PROJECT CHANGE REQUEST

PROJECT ID. 0112000126
 DISTRICT/EA 01-0B420 PPNO 2340 PGM Doc. 2014 SHOPP PGM Del FY 15/16 PROG CODE 201.131

PROJECT (SCOPE) DESCRIPTION: HUM 101 110.6/T113.8 Lagoons Slip and Slide

Subject: Revised Geotechnical Recommendations

Figure 2. -- Plan map of U.S. Route 101 at PM 113.76, EA 01-0B420, showing horizontal drains and location of the new culvert.

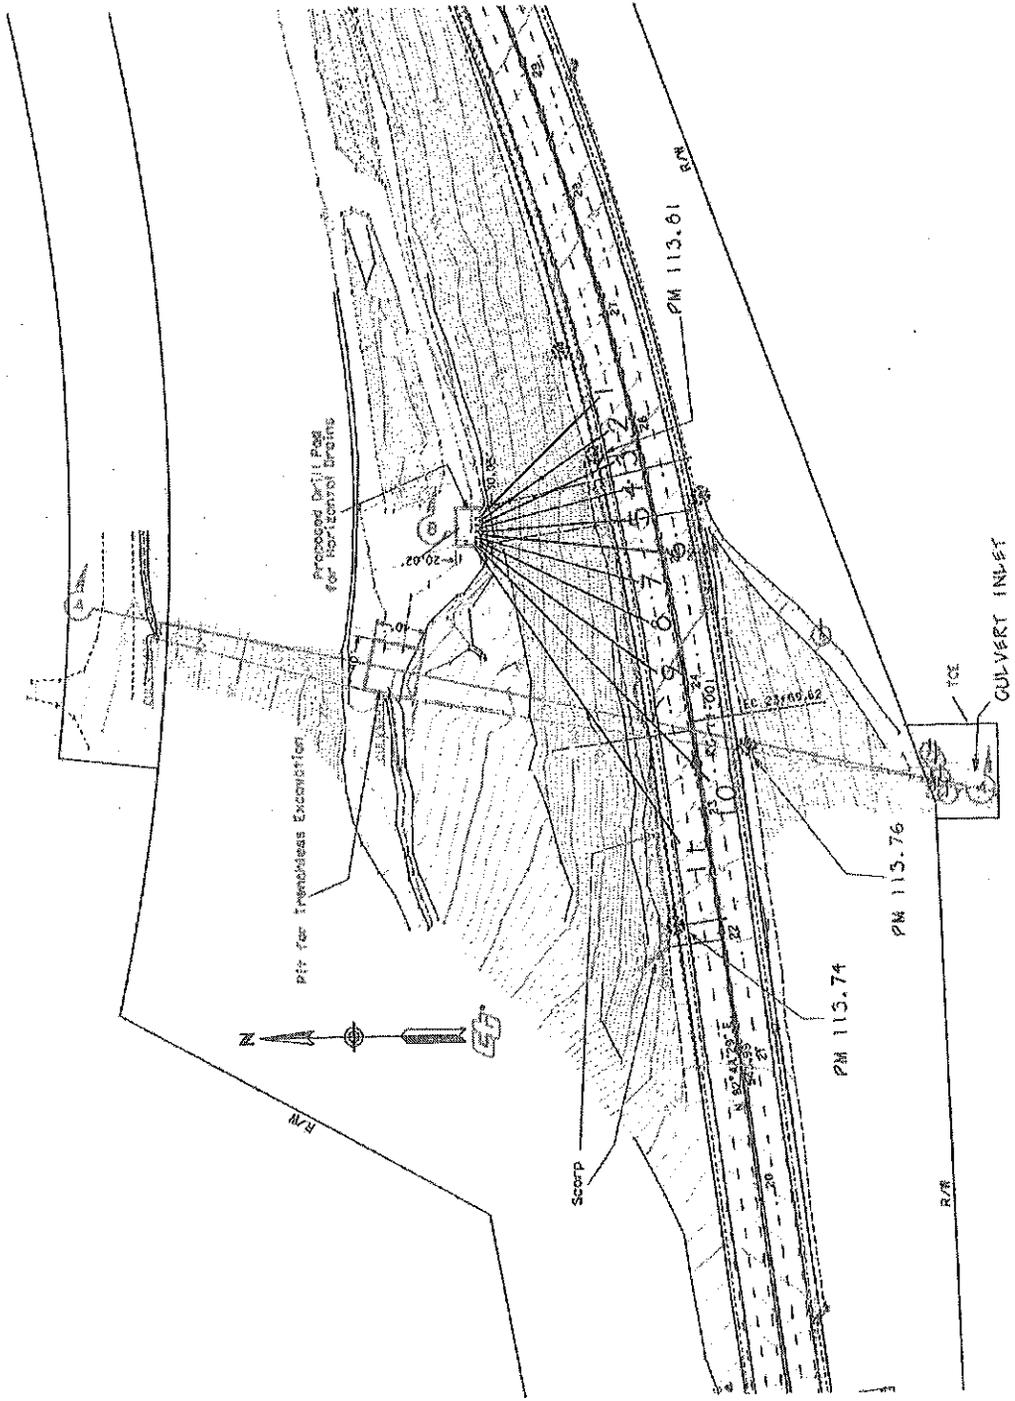
After several intense rainfall events during the winter of 2011, the existing left-side embankment failed along the left shoulder between Station 22+00 and Station 26+00 (Figure 2). The top of the failure begins along the outside edge of the roadway shoulder and terminates downhill at the toe of the embankment.

The DAF #028 recommended constructing a rock buttress, dewatering the subsurface and surface, reconstructing the shoulder as necessary, and repairing or replacing the culvert at PM 113.76. The current plan is to (1) dewater the subsurface using an array of horizontal drains, and (2) replace the existing culvert at PM 113.76 using a trenchless excavation construction method.

- 1.) Install horizontal drains prior to the new culvert pipe. The inclination of a horizontal drain drilled at a positive angle of 10° can be expected to drop approximately 2.5° per 100 feet based on instrumental measurements (Cornforth, D.H., 2005). We do not want to risk any damage to a new culvert pipe during drilling for horizontal drains.
- 2.) Install an array of 11 horizontal drains. The approximate location of the array is 120 feet left of the center line, between Station 25+37 and Station

- 7.) Figure 4 and the Standard Specifications Section 68-3 provide design and construction details for horizontal drains.
 - 8.) We estimate 11 horizontal drains should be installed (Figure 2 and Table 1).

Figure 4. Profile showing proposed new culvert (black) and existing culvert (blue).

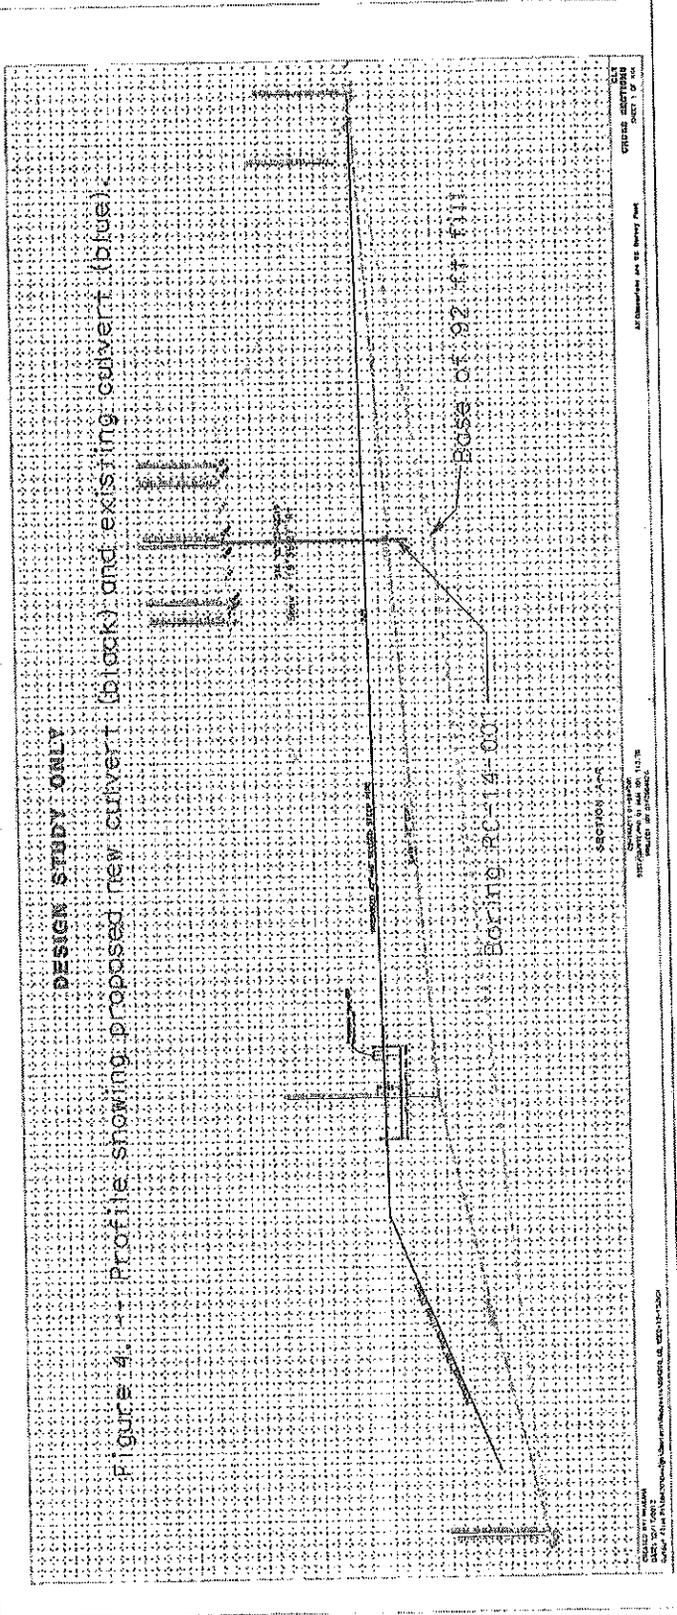
The profile (Figure 3) shows 92 feet of roadway fill at centerline, based on as-built plans (1971-1973). The existing culvert is perched at a depth of 72 feet and the new culvert will be at approximately 64 feet below the center of the highway. Deterioration of culvert pipes saturates the lower fill and leads to subsurface erosion beneath the roadway.

The plan is to replace the failing existing 42-inch diameter, 426-foot-long culvert, which is set at a gradient of -7.21%. The proposal is to install a 42-inch diameter welded steel pipe, shown as 488.9-foot-long, and set at a gradient of -2.5%. The new pipe will be installed higher in the fill. .

1. We recommend that the proposed new culvert be installed after drilling and installation of the horizontal drains. This construction sequence will protect the new culvert pipe from damage during horizontal drilling and lower groundwater before trenchless excavation for the new culvert.

2. We recommend that the new culvert pipe be installed using trenchless excavation (Appendix 2), because the depth makes open-cut (trench) construction infeasible.

4. For accuracy, we recommend using Pipe Jacking¹ or Microtunneling² to install welded steel casing of sufficient thickness to withstand the installation forces.
